Global Change Notification (GCN)

GCN Number

Series

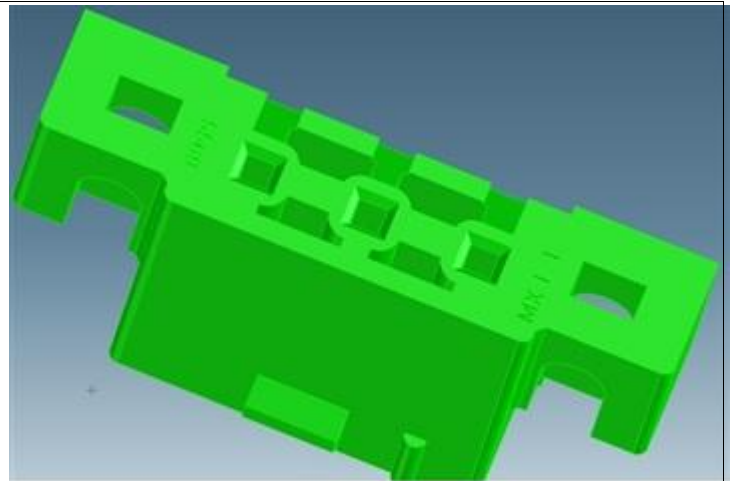
Change Description

Parts from the current tool with material saver option

Parts from the new tool without material saver option
